# UNITED STATES PATENT AND TRADEMARK OFFICE

APPLICATION NO.	FILING DATE	FIRST NAMED INVENTOR	ATTORNEY DOCKET NO.	CONFIRMATION NO.
10/693,699	10/27/2003	Farid Bruce Khalili	Ve 010	2292

**Office Action Summary**

FIG. 3

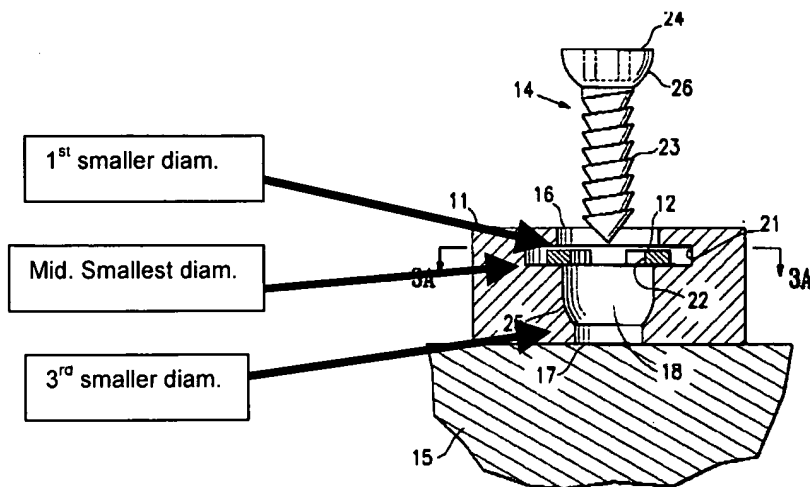
Claims 1-32 are rejected under 35 U.S.C. 102(b) as being anticipated by Talaber et al. (US Patent 6,261,291). Talaber et al. disclose an implant fastening/stabilizing system comprising a fastener (14) having a first and second ends and a shaft, the first end able to fixedly engage in a first body such as bone (15, see Fig. 1) and second end to a second body (such as 11) that may be implantable and spans between two bone structures (note split in Fig. 1), a resilient retention member (12) that is able to cooperate with the second body (see Fig. 3a) and that is considered a split ring that is capable of causing a fastener to move between a retained and non-retained condition because it is capable of producing a bias (Col. 4, lines 13-23) between either a relaxed or flexed state. The fastener comprises screw threads (see Fig. 2). The second end of the fastener, or at least a fastener retention system, is also considered to be a locking portion that has a larger diameter section (21) that fits between two smaller diameter sections. See drawing below with emphasis.

Within the large diameter section, the split ring may be positioned, through which it must be passed by a fastener in order to be removed. Depending on how it is viewed, the split ring may be fitted into a smaller diameter setting, if it is appropriately adjusted, where it could also be positioned, as a functional limitation, around a smaller diameter setting. The larger diameter in the second body, is also considered to be subsurface and the split ring has a greater outer diameter in its relaxed stated compared to the surface diameter, which is being considered as the "above smaller diameter."
